RE: Environmental Protection Agency
Docket number EPA-HQ-OAR-2011-0660
Proposed Rules for GHG Emissions for Electric Utility Generating Units

Submitted By: Gas Turbine Association
Dr. William H. Day, Managing Director
billday3@comcast.net

Figure 1. CO₂ emissions as a function of fuel choice and cycle efficiency (based on Higher Heating Value)

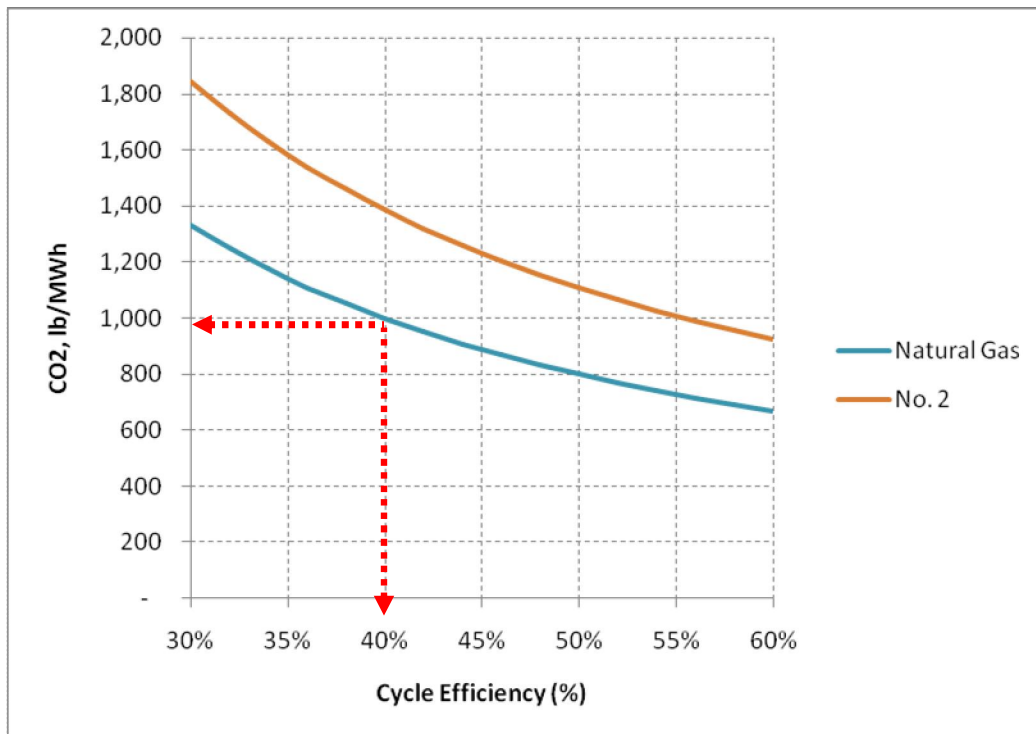
Because of the stringency of the proposed compliance level, GTA requests EPA clarify that the NSPS rule only apply during periods of natural gas operation with an exemption for 500 hours of operation on backup fuel. During periods of extreme weather events (typically cold winter days), plants operating with interruptible gas supplies may be forced to use an alternative or backup fuel. Most commonly the backup fuel is number 2 distillate (or similar fuels); which have a significantly higher CO₂ emission profile.² As Figure 1 shows, there is a large difference between emission levels based on natural gas and other fuels. An exemption to operate on a backup fuel for a period of up to 500 hours per year would accommodate the potential need to use a back up fuel.
